South Dublin County Council Planning

Re: Additional Information
Proposed Planning Application for
2 Haydens Park View Esker South, Lucan, Co. Dublin, K78 NY82
Reg Ref: SD22B/0432

Please find attached additional information in support of the above planning application:

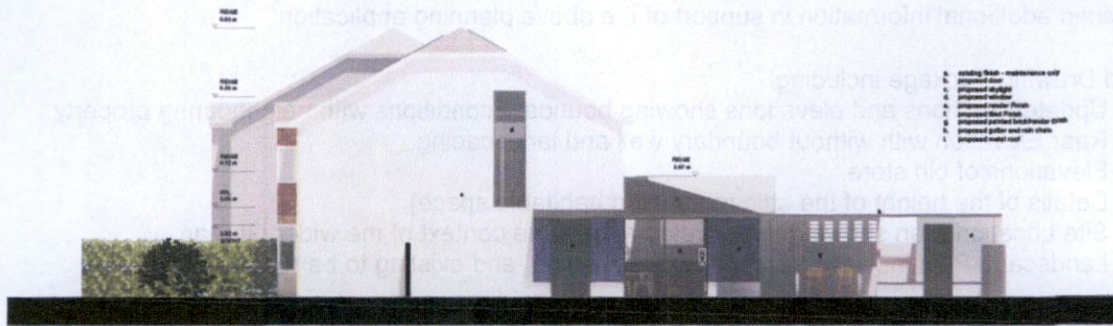
The site is located on the L2 Green Infrastructure Route, overlooking Griffeen Park and Griffeen River. The views to Griffeen Park are one of the best features of the house, and the scheme has been designed with this consideration. As per the additional information's request we have prepared a landscape plan and site location plan to address the requirements of the South Dublin County Council Green Infrastructure plan, to promote the development of an integrated GI networks, and enhance existing biodiversity and natural heritage, improving our resilience to climate change.

The attached landscape plan indicates a summary of the proposed and existing planting to the rear and front garden.

To the front garden we are retaining the majority of the existing landscaping. The existing boundary hedgerow is to be retained as is. The existing flowerbed, lawn and driveway in the front of the living room will also be retained. The southern lawn will be dug up to top soil and prepped to take native Irish wildflowers. These meadows have been shown to provide greater biodiversity and improve the area for the local pollinators. The total area of the front garden is 91 sqm.

The rear and side garden have been altered substantially to provide a terraced area to reduce upkeep and provide generous external seating, regardless of the weather. The terraces have been positioned to provide spill out spaces from the proposed internal area, with matching internal and external floor finishes. These spill out spaces, are both covered and open, allowing the houses main living space to expand and contract as needed. The terraces also provide circulation to the proposed rear bike shed, which provides additional security for storing bikes and tools and an area for maintenance.

There is an existing rendered wall with brick piers and capping to the southern boundary wall. It is proposed that no changes be made to this wall. This existing wall is approximately 1.7m high. Climbing plants are currently scattered across it to our client's side and we would hope to retain them as much as possible as part of building works. A bin store is provided behind this wall and is not visible from the front garden. The adjacent area is also proposed to allow for a bed of native Irish flowers.

PROPOSED SIDE ELEVATION
scale 1:100

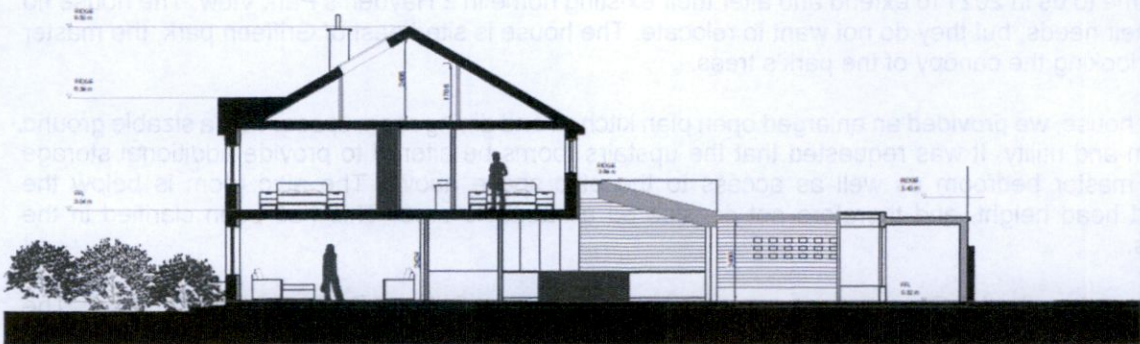
As part of this proposal, we have reviewed the councils' requests for revising the roof profile to a flat roof as shown below in the elevations and sections.

After reviewing the flat roof proposal with our clients, it was agreed that a hipped roof would be preferred for reasons of aesthetics and maintenance. Therefore, we would propose the retention of the original hipped roof scheme to the covered area. In support of this, we would note the following:

- As per the, S.I. No. 600/2001 - Planning and Development Regulations, 2001, under Class 3 exempted development, awnings and storage areas under 25sqm and a height of 4m or under should be considered exempted development. The original proposed scheme has a covered area (including the extensions roof overhang) of 31sqm. If we exclude the roof overhang, we have a covered area of 26 sqm under 4 meters high. The proposal is larger than the exempted 25sqm, but only marginally so.
